Access Compliance Report Public Rights-of-Way (Curb Ramps)

Main Street: ROCKHURST_ST Cross Street: NEWPORT_BLVD Location: NE

ADA ID: RPRK211012151715 Ramp Type: Type 1 - Perpendicular Diagonal Initial Pass/Fail: Fail Overall Compliance: No Severity Score: 2

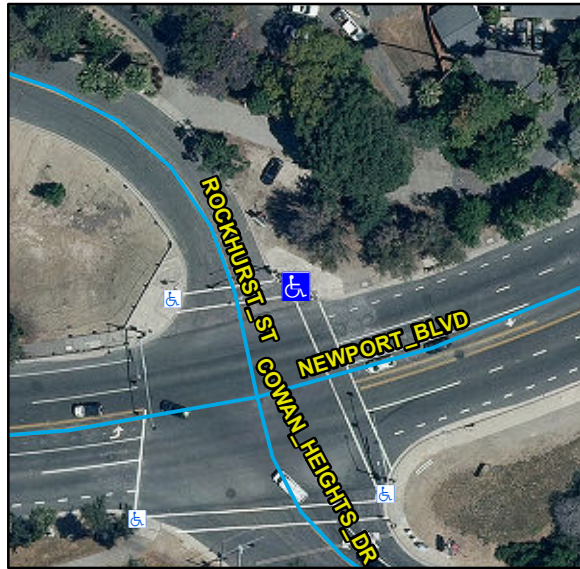
Compliance	Description	Data	Compliance	Description	Data
N/A	Ramp Length (in)	113	N/A	Flare Type LT	
Yes	Ramp Width (in)	48			N/A
Yes	Ramp Run Slope (%)	6.3	N/A	Flare Slope LT (%)	N/A
No	Ramp Cross Slope (%)	3	N/A	Flare Traversable LT	N/A
N/A	Landing Present	N/A	N/A	Flare Type RT	
N/A	Landing Length (in)	N/A			N/A
N/A	Landing Width (in)	N/A	N/A	Flare Slope RT (%)	N/A
N/A	Landing Run Slope (%)	N/A	N/A	Flare Traversable RT	N/A
N/A	Landing Cross Slope (%)	N/A	N/A	DWS Provided	N/A
N/A	Landing Movement Obstructed?	N/A	N/A	DWS Contrast	N/A
	Landing Movement Type	N/A	N/A	DWS Length (in)	N/A
N/A	Landing Shared	N/A	N/A	DWS Full Width	N/A
N/A	Clear Space	Yes	N/A	DWS Offset Left (in)	N/A
N/A	Clear Space To Crosswalk (in)	48	N/A	DWS Offset Right (in)	N/A
N/A	Marked Crosswalk 1	Yes	N/A	Marked Crosswalk 2	Yes
	Crossing 1 Direction	W		Crossing 2 Direction	S
	Marked Crosswalk 1 Width (in)	144		Marked Crosswalk 2 Width (in)	144

N/A	Ramp Inside Crosswalk 1	Yes	Yes	Ramp Inside Crosswalk 2	Yes
	Crossing 1 Slope (%)	4.7		Crossing 2 Slope (%)	8.8
	Crossing 1 Cross Slope (%)	1.4		Crossing 2 Cross Slope (%)	1.5
N/A	Gutter Ponding	N/A	No	Curb Slope	8.9
Yes	Gutter Lip Height (in)	0		Road Run Slope (%)	1
N/A	Gutter Run Slope (%)	N/A		Road Cross Slope (%)	9.7
N/A	Gutter Cross Slope (%)	N/A			
Yes	Overall Surface Condition: Acceptable		No	Perp Joint Present	No
	Cross Gutter Present?	No		Spandrel Present?	No
	Replace Cross Gutter?	N/A		Replace Spandrel?	N/A

Remove & Replace Curb Ramp With Two New Directional Ramps or Equivalent.

R304.2.2, R204.3, R304.5.3, STD 1115
